# Service Advisory

CC-568

Date: **April 26, 2007**

Subject: **Hydrostatic Transmission (Hydro) Dump (By-Pass) Rod With Pull Stop Limiter Fix-As-Fail**

**FIGURE 1**

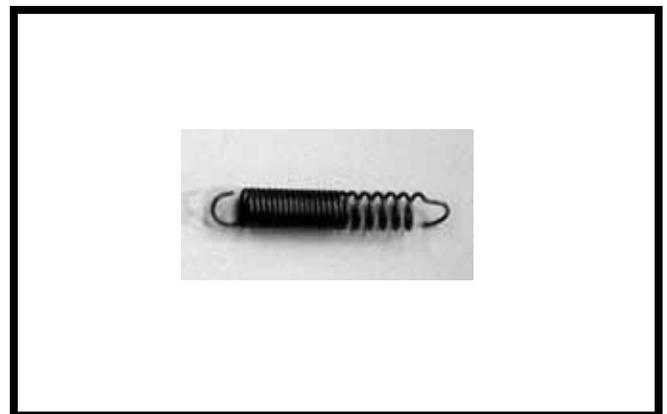
1. Inspect both hydrostatic by-pass valve levers, see Figure 1, to ensure they move freely over their full travel. If a by-pass valve lever does not move or does not release the hydrostatic transmission, i.e. wheel will rotate by hand, when moved to it's furthest rearward position, the problem is with the hydrostatic transmission.
2. If either or both extension springs look like the one shown in Figure 1, then the springs are good and no further action is required. If either or both springs look like the one in Figure 2, it has been over loaded (over-stretched) and must be replaced.

3. If the by-pass valve lever is free to move it's full travel but either one or both of the springs are over-stretched as shown in figure 2, then order and install Service Kit **753-05590**.
4. Service Kit **753-05590** will contain two new hydrostatic dump rods with a added pull limiting stop feature, springs and instructions. The dump rod's stop feature limits the amount of spring extension (i.e. spring load) allowed thereby eliminating the potential to over extend the spring.
